Residential Development Baldoyle GA2

Stage 1 Road Safety Audit

<b>Client:</b>	Lismore Homes Limited
<b>Project Title:</b>	Residential Development Baldoyle GA2
<b>Document Title:</b>	Stage 1 Road Safety Audit
<b>File Name:</b>	20211-BT-00-XX-RP-C-02001_Stage 1 Road Safety Audit.docx

Figure 2: Example of pedestrian crossings not lined up with desire lines

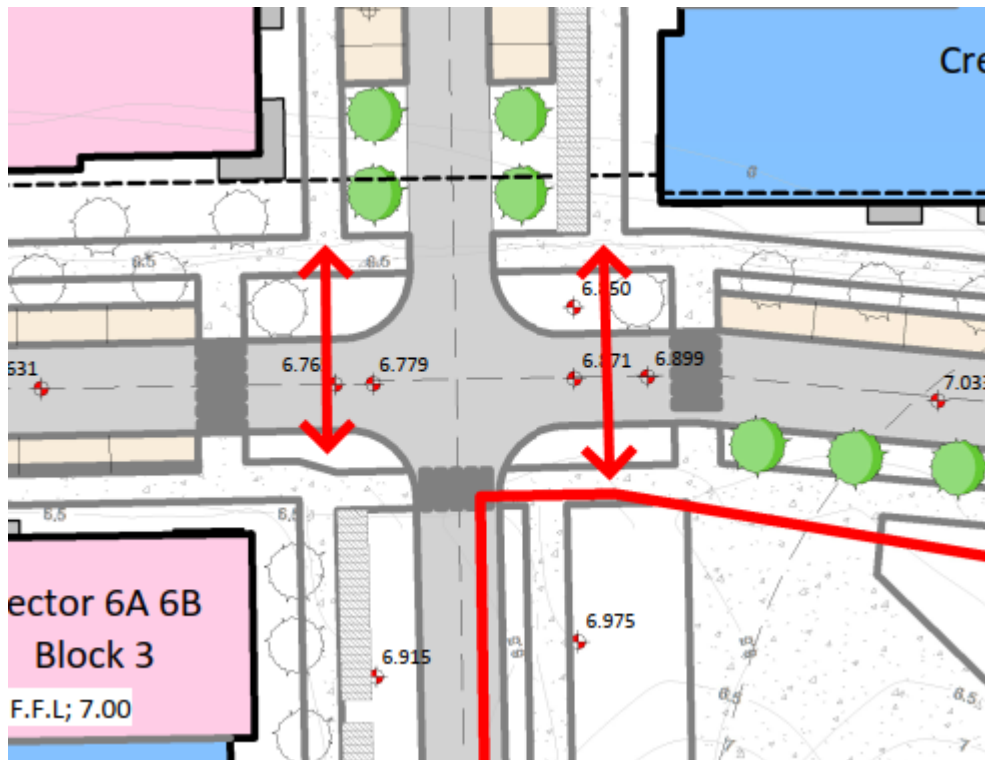
### 2.4 Problem: Pedestrian Crossings Offset From Desire Lines

Some pedestrian crossings are offset from the pedestrian desire-line. Pedestrians are more likely therefore to cross at a location where they may trip on kerbs. This may also lead to confusion as drivers might not expect pedestrians away from designated crossings, resulting in vehicle/pedestrian collisions.

#### Recommendation

Crossings should be provided on pedestrian desire-lines.

2.1	Yes	Yes	Raised tables introduced.	
2.2	Yes	Yes	Raised tables introduced.	
2.3	Yes	Yes		
2.4	Yes	Yes		
2.5	No	No	Direct connection points to the Portmarnock to Baldoyle Greenway are not possible as the client is not in control of the lands necessary to provide the link. Links are provided to the public open space directly to the north of the proposed development. This public open space links directly to the Portmarnock to Baldoyle Greenway.	Yes

**Figure 3: Mixed types of pedestrian crossings throughout the scheme (blue-zebra, red-uncontrolled).**

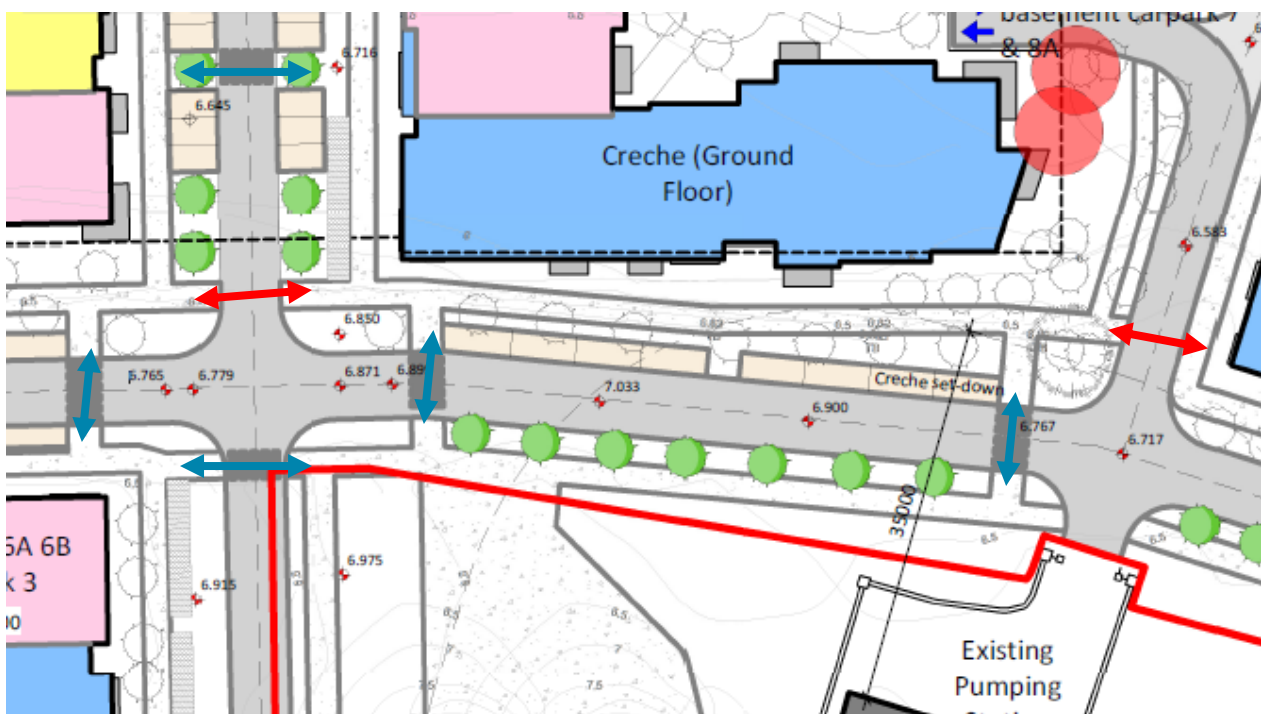
## 2.8 Problem: Mixed Use of Zebra and Uncontrolled Pedestrian Crossings

There appears to be a mix of zebra and uncontrolled, courtesy pedestrian crossing points proposed throughout the development. This inconsistency could confuse road users as to priority on crossings and lead to pedestrian/vehicle collisions.

### Recommendation

Ideally only one type of crossings should be provided through the scheme. However, if there are reasons to differentiate, a more coherent approach should be applied to ensure the road environment is self-explanatory and consistent.

2.6	Yes	Yes		
2.7	Yes	Yes	Tree planting will be maximised as much as practicable along link roads.	
2.8	Yes	Yes	Design revised to show only one type of crossing.

**Figure 4: Example of a restricted visibility from one of the underground car park exits.**

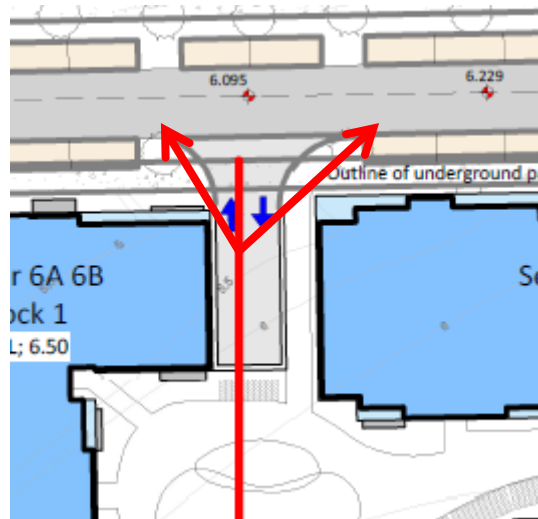
## 2.9 Problem: Underground Parking Exits

Some underground car park exits have restricted visibility to the footpath due to retaining walls and/or building corners. This could lead to vehicle/pedestrian collisions as exiting drivers might not see the crossing pedestrians in time to react.

**Recommendation**

Adequate intervisibility between drivers exiting underground car parks and crossing pedestrians should be provided.

2.9	Yes	Yes

**Figure 5: The pedestrian crossing detail that seems to be confused**

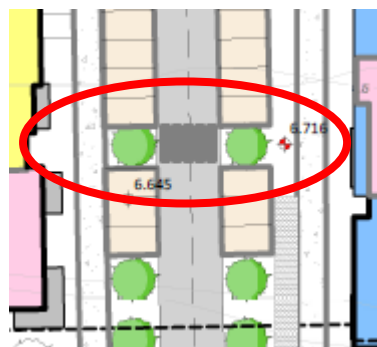
**2.12 Comment: Trees Indicated at Pedestrian Crossing**

The detail of the pedestrian crossing between Sectors 7 and 8 seems to be confused, as there are no footpaths leading to it and there are trees proposed in the footpath at either side of the crossing.
